MEMORANDUM FOR: John Greeves, Chief
 Engineering Branch
 Division of Waste Management

FROM: Malcolm R. Knapp, Chief
 Geotechnical Knapp
 Division of Waste Management

SUBJECT: DRAFT FINAL REPORT - BASALT WASTE ISOLATION PROJECT:
 HANFORD SITE DISQUALIFYING CONDITION - PRELIMINARY POSITION
 FOR REPOSITORY WATER INFLOW UNDER HIGH PRESSURE SEPTEMBER 1984

Figure 1. Flowrate vs. transmissivity for each step.
 TI-109 Cohasset Interior.
 4 Step Injection Test

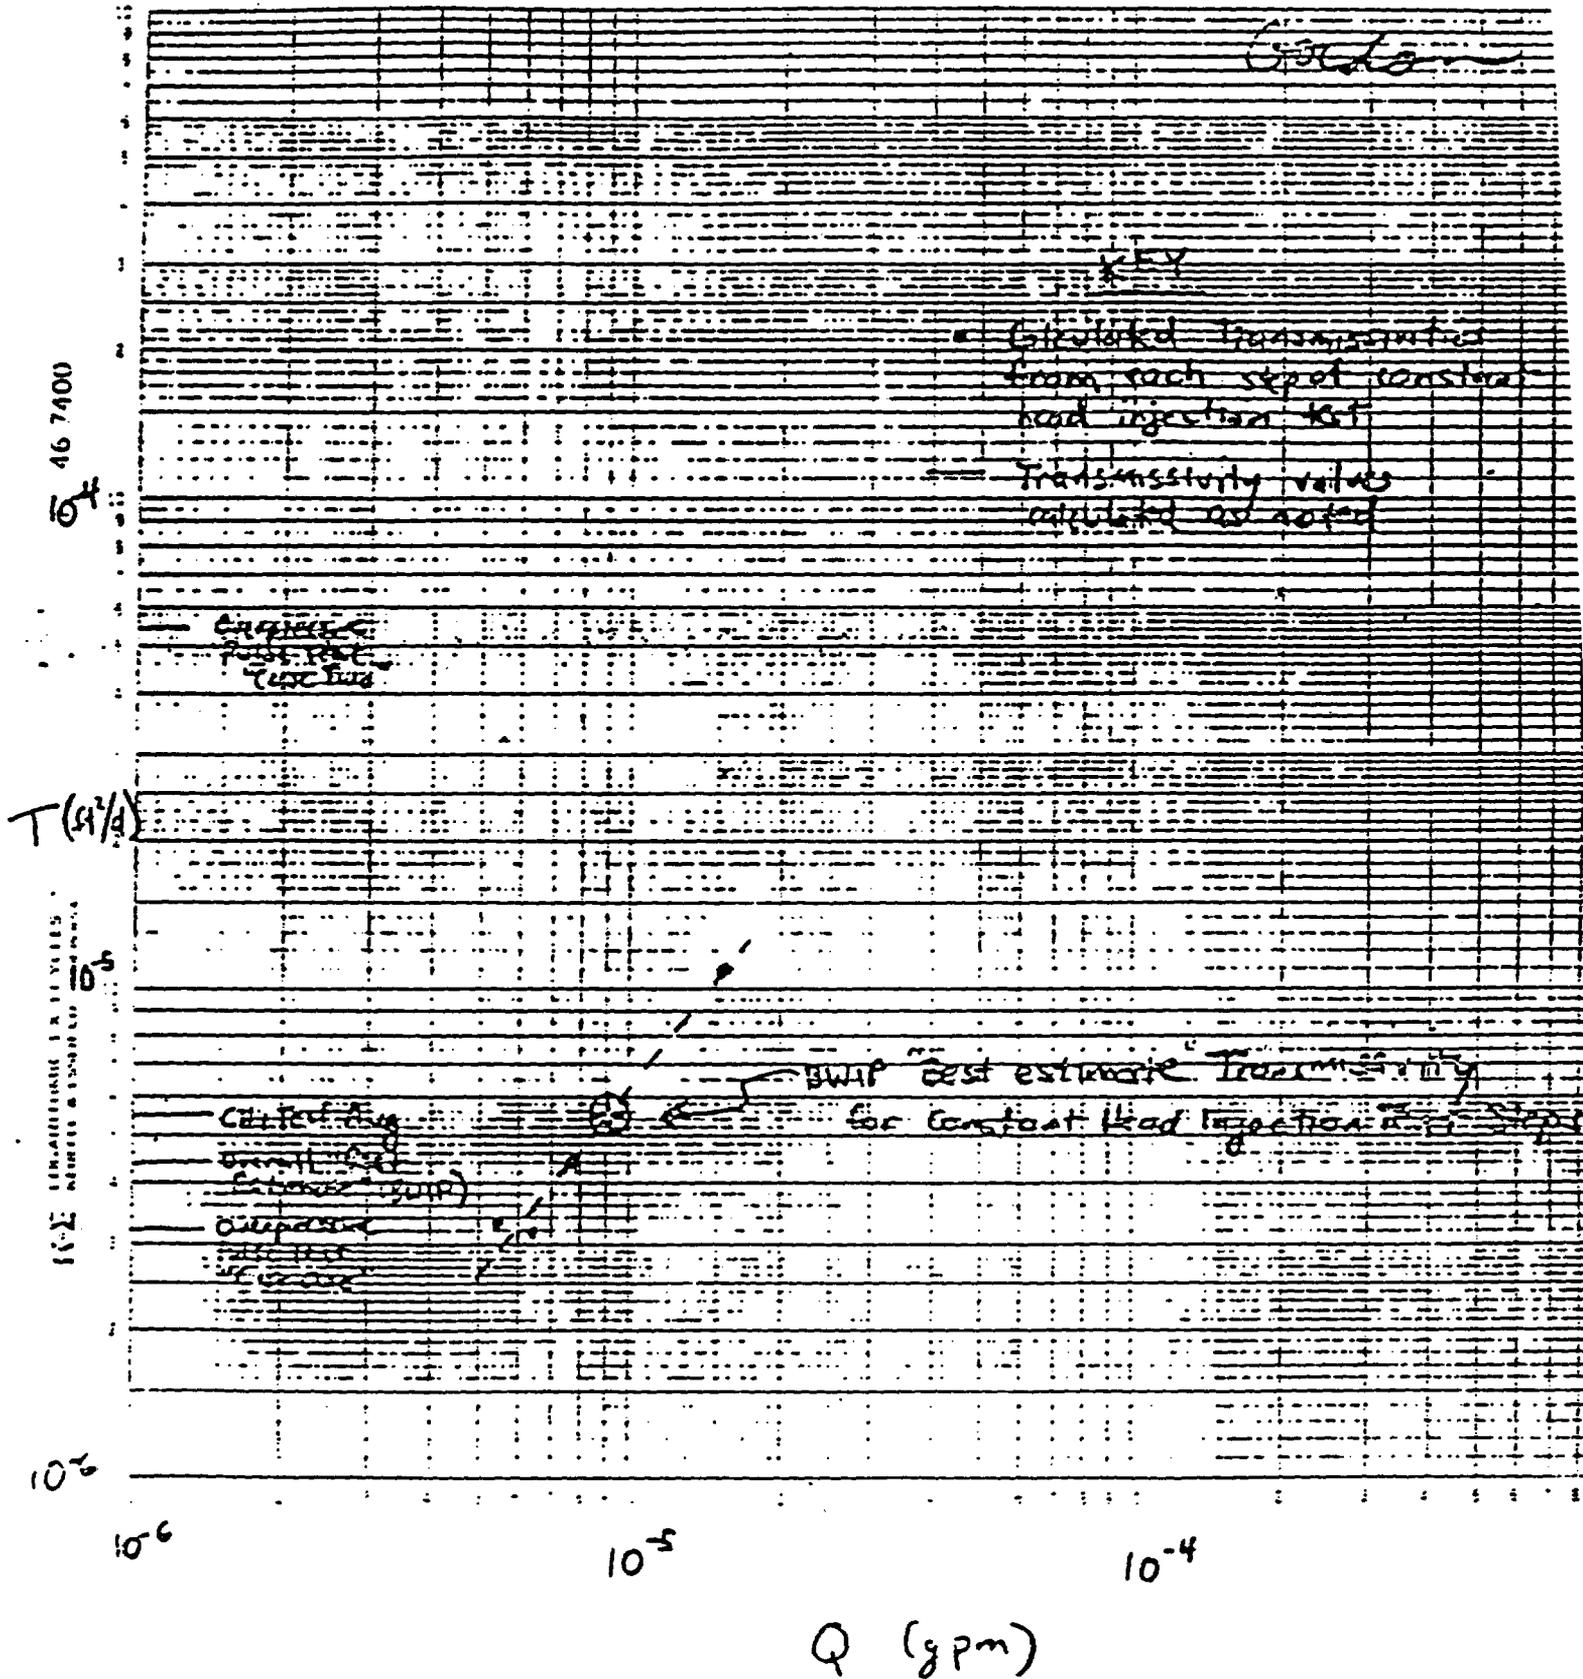
- 1) BWIP has ignored the fact that the responses to the four steps of the described constant head injection test are inconsistent with theoretical responses. This inconsistency calls the constant head injection test results into question.
- 2) BWIP chose an average, rather than a conservative value for their "best estimate" of constant head injection test results.
- 3) The described overpressure pulse test appears to have been analyzed in two ways: one contrary to existing literature on the subject (yielding a low value of transmissivity) and the second consistent with existing literature on the subject (yielding a transmissivity value an order of magnitude higher). The results of the second (correct, based on existing literature) analysis were thrown out, apparently because the yielded transmissivity was higher than expected.
- 4) No storativity values were reported.

BWIP does not indicate the temperature of injected fluid; this could make their estimates of imposed heads erroneous, as NRC has pointed out in reference to other tests at BWIP (c.f., Wright to Olson, May 25, 1984). Regardless of this point, however, the results presented by BWIP in Table 2 of the subject report (attached) indicate substantial irregularities in these tests. Figure 1 shows the calculated transmissivities as a function of the steady-state flow rates for each step. These should theoretically plot along a straight horizontal line. Figure 2 shows the steady flow rate as a function of the imposed head. This should plot as a straight line of positive slope with flow (Q)=0 intercept at imposed head (H)=0. However, this is not the case for the BWIP tests. For example, the BWIP tests indicate that the lowest head imposition required the highest flow rate to maintain, which is contrary to the theoretical response. The only portion of the plot which even has positive slope is section B; however, this section has a Q-intercept (H=0) at $-1.56e-5$ gpm, rather than zero.
